**SUBMISSION TO DRAFT WESTCONNEX M5 EAST (SSI 6788)
215-225 EUSTON ROAD, ALEXANDRIA**

We thank you for the opportunity to comment on the Environmental Impact Statement for the *WestConnex New M5* (SSI 14_6788) currently on public exhibition.

Figure 2: Proposed Road Upgrades – Euston Road (site outlined in red)

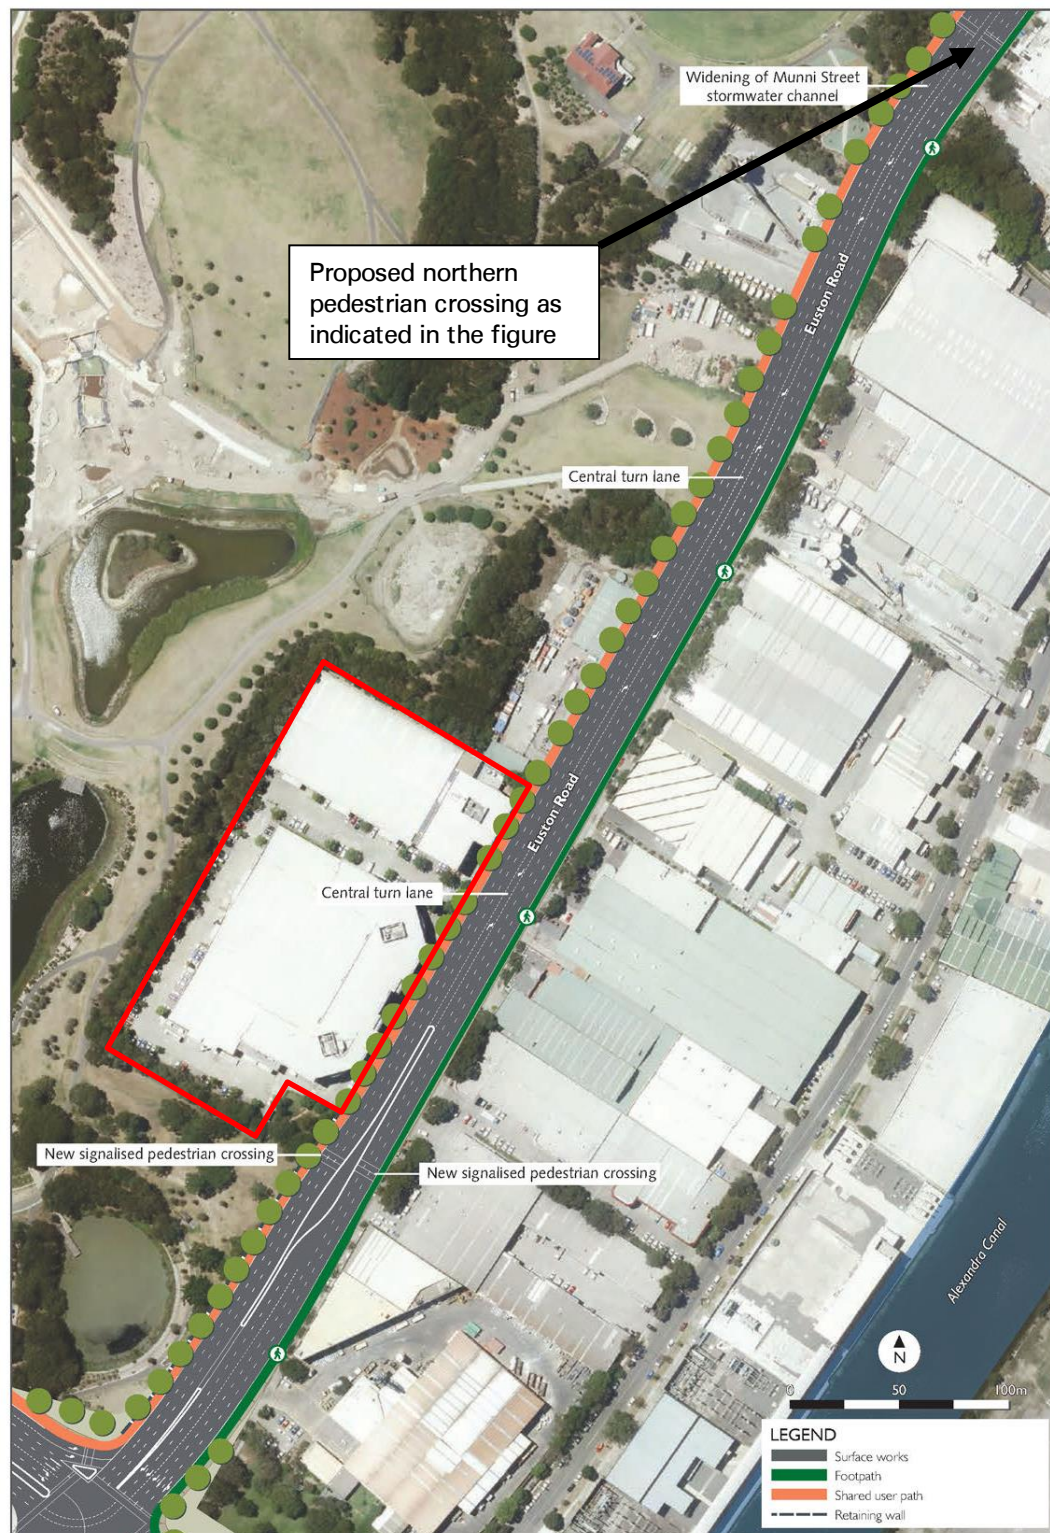
Hailiang is supportive of the proposed pedestrian intersection (and particularly the absence of a median strip or concrete barrier) across Euston Road in front of the site (as shown below in **Figure 2**), as well as the central turn lane that would allow southbound vehicle to enter the site, crossing Euston Road.

It is also requested that WestConnex provide clarification that pedestrian crossing east/west across Euston Road further north of the site (as indicated on Figure 5-29 of the EIS) will be delivered. In the diagrams and EIS document, this is not clear, but is supported by Hailiang.
